UNITED STATES  
DEPARTMENT OF THE INTERIOR  
BUREAU OF LAND MANAGEMENTFORM APPROVED  
OMB NO. 1004-0137  
Expires: January 31, 2018**SUNDRY NOTICES AND REPORTS ON WELLS**  
*Do not use this form for proposals to drill or to re-enter an abandoned well. Use form 3160-3 (APD) for such proposals.*5. Lease Serial No.  
NMLC032100

☒ Oil Well ☐ Gas Well ☐ Other8. Well Name and No.  
CH LOCKHART -1 07

CHEVRON USA INC RESPECTFULLY REQUESTS TO RECOMPLETE THE ABOVE WELL INTO THE PADDOCK/GLORIETA FORMATION. THE RECOMPLETION PROCEDURE IS AS FOLLOWS:

\*\* BLM REVISED \*\* BLM REVISED \*\* BLM REVISED \*\* BLM REVISED \*\* BLM REVISED \*\*

## Proposed Wellbore Diagram

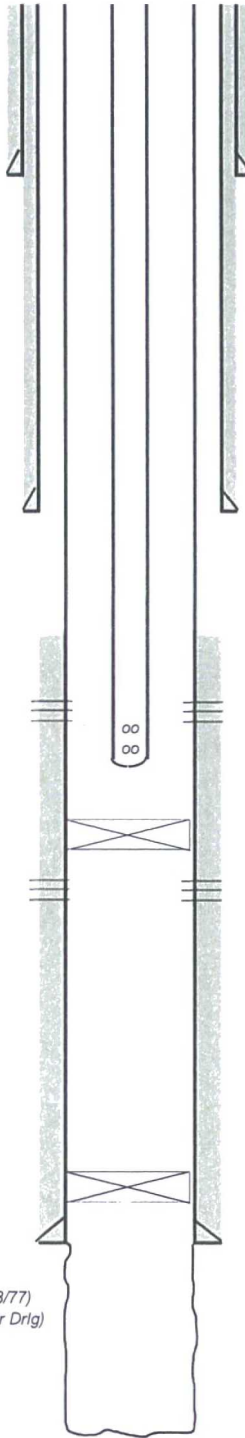
ADD CIB 6710' w/100' cmt pumped on top

Set CIBP @ ~~5572'~~ <sup>5582</sup>

Set CIBP @ --6710'
